Nebraska Public Power District

NLS8800352

Subject: Reactor Vessel Water Level Instrumentation in BWRs, Generic
Letter 84-23, Cooper Nuclear Station NRC Docket No. 50-298,
DPR-46

Changes to Core Spray Reference Leg Fill System

GENERAL DIVISION		DATE	
TO: GENERAL DIVISION		BY: [Signature]	
FROM: [Signature]		DATE: [Date]	
REFERENCE: LEG INJECTION			
N. P. P. D.			
FLOW DIAGRAM			
NO. 88005		FD-001	
SHT 1 of 1		1

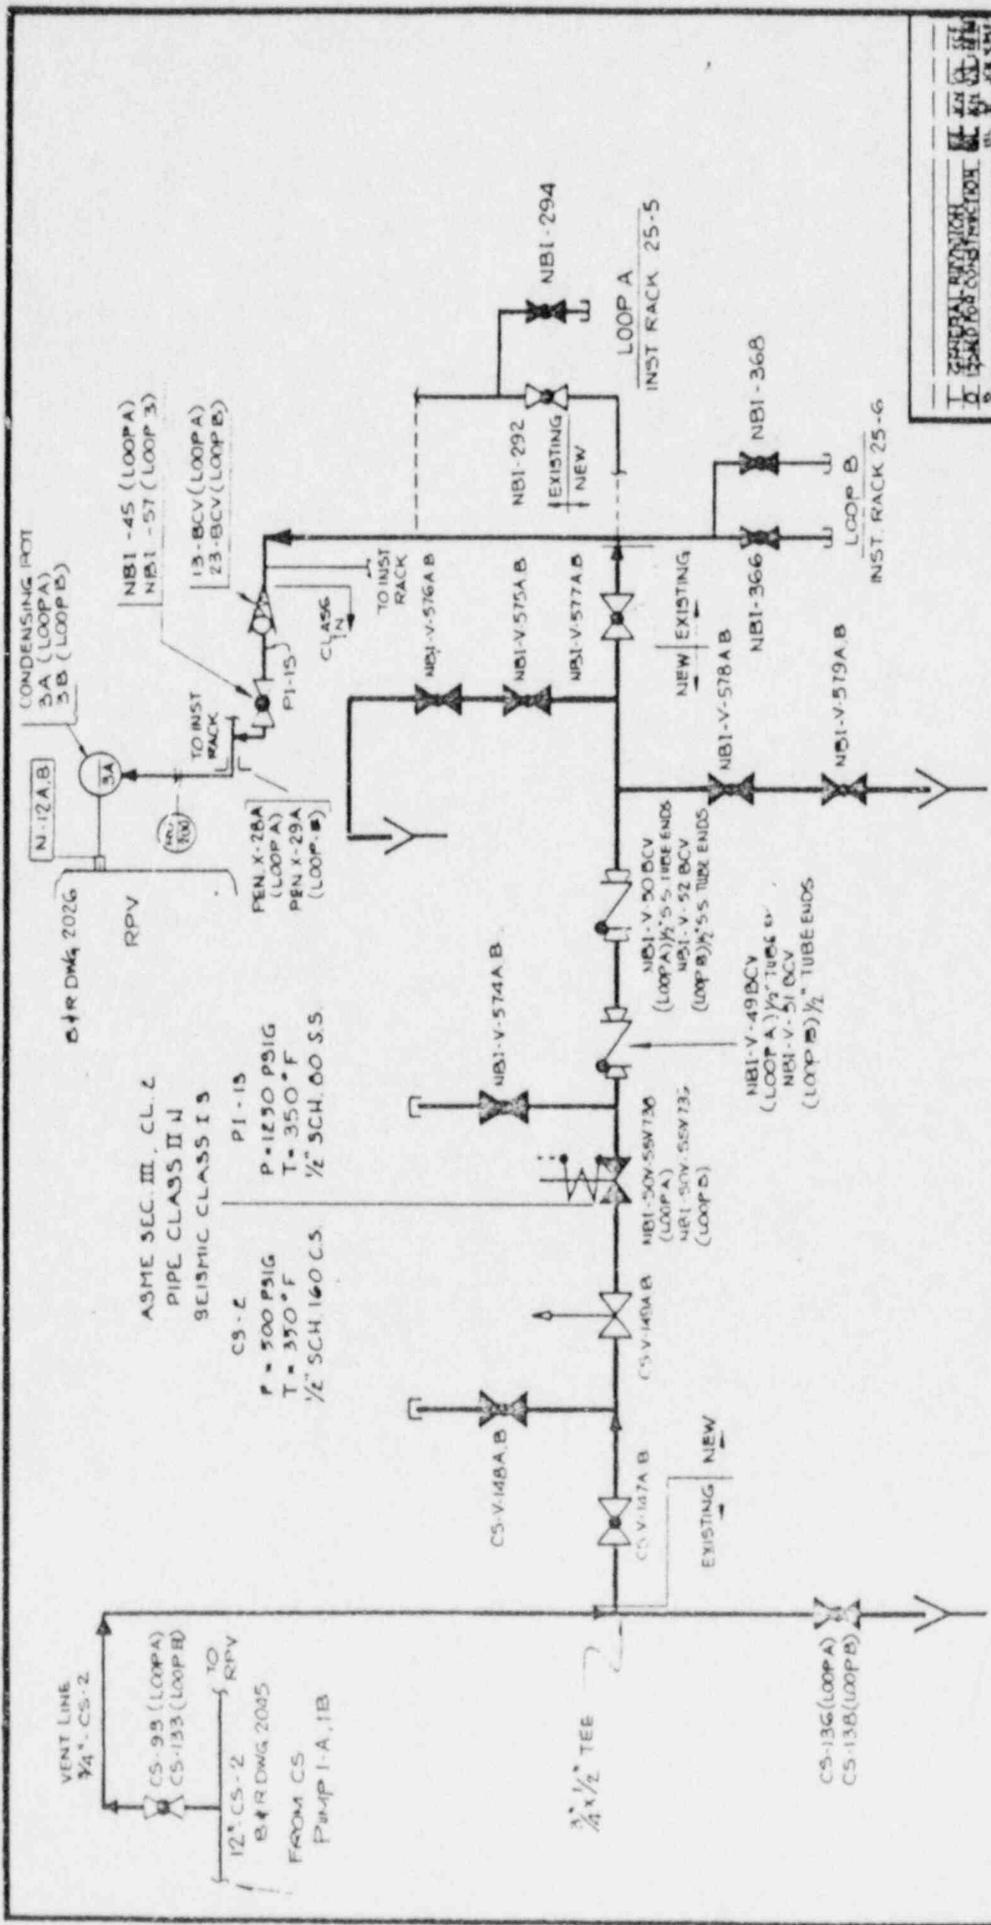
1. Remote Manual Operation to Local Manual Operation

The solenoid valves NBI-SOV-SSV-738 and 739, purchased to provide remote manual initiation of the make-up flow to the reference legs, were also intended to provide part of the isolation barrier to prevent flow from the reference legs to the low pressure core spray system. The valve specifications appeared to indicate that this valve, when closed, would retain 1375 psi in either direction. However, during the post installation hydrostatic test, it was discovered that the valve would not hold pressure in the reverse-flow direction. The vendor verified that the valve was only designed and capable of isolation in the forward-flow direction.

Although the hard seated check valves provide an acceptable barrier for piping design pressure change, they will exhibit some leakage, estimated to be less than 3 cc/min. in the reverse flow direction. The District feels it is prudent, and the original implemented design concept intended, to have an additional barrier to prevent any flow of water from the reference leg. To maintain this important design consideration, and as an interim measure until acceptable solenoid valves can be procured and installed, a manual isolation valve, NBI-V-577A(B) located downstream of the two check valves, will be closed to ensure the integrity of the reactor vessel water level reference legs.

The operating procedures have been modified to maintain the manual shutoff valves (NBI-V-577A and B) normally closed in each loop of the core spray reference leg fill system. The operating procedures also provide instructions to the operators to open the manual valves locally, if injection is required. This change in system operation is only intended for one operating cycle, to allow solenoid valves that will isolate in either direction to be obtained and installed during the next refueling outage.

2. Water Filter

The conceptual design, provided to the NRC in Reference 2, suggested installing a filter at the origin of the reference leg piping to assure that the injection water is free of particulate matter. The installed Design Change does not include a filter for the following reasons:

3. Restriction Orifice

The conceptual design utilized a restriction orifice to limit the flow to the required rate and to work in conjunction with a differential pressure indicator to measure the flow. The installed design utilizes a needle valve so that the flow can be adjusted in the field to the desired rate. This eliminates the need to depend on a calculation to size the orifice, and gives CNS the flexibility to adjust the flow to any desired rate within the capability of the needle valve.

4. Differential Pressure Indicator

The differential pressure indicator was to be used to locally monitor flow rate during routine surveillance testing. The installed design deleted this indicator when the restriction orifice was deleted. Initial acceptance testing performed to set the needle valve position, utilized direct measurement of flow from the drain connection to verify equivalent flow to the reference leg of 0.2 to 0.5 gpm.

5. Differential Pressure Switch

A differential pressure switch was included in the conceptual design to prevent the solenoid valve from opening if the line pressure downstream of the solenoid valve (reference leg pressure) is greater than the line pressure upstream of the solenoid valve (core spray pressure), thus preventing overpressurization of the core spray system. However, the two check valves in series perform this same function, and existing core spray system relief valves 11-RV-17 (Loop A) and 13-RV-17 (Loop B) will protect the piping if leakage past the check valves and the solenoid valve result in pressure in the core spray piping greater than design. In addition, a high pressure condition in the core spray piping would be alarmed in the control room.

6. ASME Sec. III Class 1 Code Designation

The conceptual design identified two alternatives for providing core spray make-up to the reference legs. One alternative was to inject water into the ASME Class 1 piping inside the drywell. The other alternative allowed injecting the core spray water at the reactor water level instrument racks. This second alternative was chosen. Since the make-up water is not injected into the Class 1 portion of the reference leg piping, but instead, is injected downstream of the Class 1 piping boundary defined by the excess flow check valve, the injection piping is designated as Class 2.

7. Reference Leg Insulation Inside Containment

The conceptual design called for insulation on the reference leg piping inside containment to avoid flashing or boil-off due to high drywell temperature. As a part of Design Change 87-113, the District performed heat transfer calculations under postulated temperature and pressure conditions where reference leg injection is required. These calculations demonstrate that insulation is not required to ensure injected water does not reach saturation prior to arriving at the condensing pots. Therefore, no insulation was installed on reference leg piping.

8. Error Due to Injection Flow

The conceptual design, which was developed by General Electric and submitted to the NRC in response to Generic Letter 84-23, stated that the maximum error induced in the indicated water level is 2 inches of water. This induced error is caused by the flow restriction of the 1/4 inch restricting orifice in the reference legs and an injection flow rate of 0.5 gpm. Detailed calculations performed as a part of Design Change 87-113 show that the actual maximum error induced at 0.5 gpm injection flow rate is 7 inches of water. This discrepancy in the conceptual design was due to the assumption that the existing cold reference leg restriction device was a smooth edged venturi. The actual restricting orifice installed at CNS is a square edged device, resulting in the higher pressure drop.

This change does not alter the design of the system. The system was designed to be a manually operated system. With this interim operational modification, remote manual operation will not be possible. Due to the relatively slow progression of events during which this system is required to operate, local manual operation instead of remote manual operation does not functionally change the system design concept. Also, the areas where the manual isolation valves are located (931'-6" elevation of the reactor building, one near instrument rack 25-5 and one near rack 25-6) are accessible and radiologically safe during the small break LOCA and loss of drywell cooling events. The existing Safety Evaluation Report approves the use of a manually initiated system. Therefore, the use of a remote versus a local manually operated system does not invalidate the safety evaluation.

This local manual operation is only intended to be used for one operating cycle. The system will be upgraded during the 1989 outage.

This is not considered a significant concern since the error will be induced in the conservative direction. That is, the induced error will show reactor water level to be lower than actual reactor vessel water level. This small error, therefore, could only lead to operator actions or trip functions or ECCS initiation taking place at a water level that is actually 7 inches higher than indicated. The result is that action is taken while reactor water level is at a slightly more conservative (higher than indicated) water level. Based upon the above, the small error induced by the reference leg injection system does not pose a safety concern and the NRC Safety Evaluation, which found the error to be acceptable, is still valid.
